**SUNDRY NOTICES AND REPORTS ON WELLS**  
*Do not use this form for proposals to drill or to re-enter an abandoned well. Use form 3160-3 (APD) for such proposals.*

8. Well Name and No.  
GISSLER B 14

9. API Well No.  
30-015-22004-00-S1

\*\* BLM REVISED \*\*

# Gissler B #14

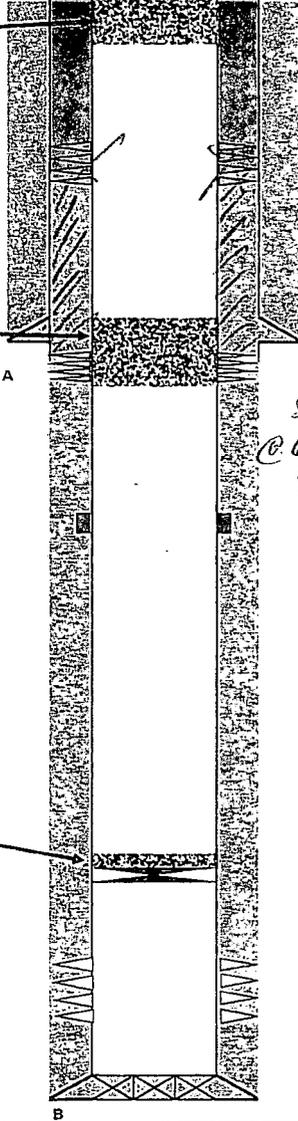
Add Plug, Perf @ 1350, SQZ  
cut to 1250. 1000 Top (B.S.)

Set CIBP at 2844 ft with 35 ft of CLS C on top. *or spot 25 sx.*  
Perforate at 673 ft. Attempt to establish circulation. Spot a 25 sx (562 ft) CLS C cement plug 211 *Spot cut from 650*  
*- Surf. Note. CSF repair. Perfed @ 600 SQZ cut surface..*

~~ft -573 ft. WOC & Tag Plug. This will plug the 8-625 inch casing shoe and Saldado.  
Spot a 10 sx (145 ft) CLS Cement plug 0 ft - 145 ft. WOC & Tag Plug. This will plug the Top.~~

SEE ATTACHED FOR  
CONDITIONS OF APPROVAL
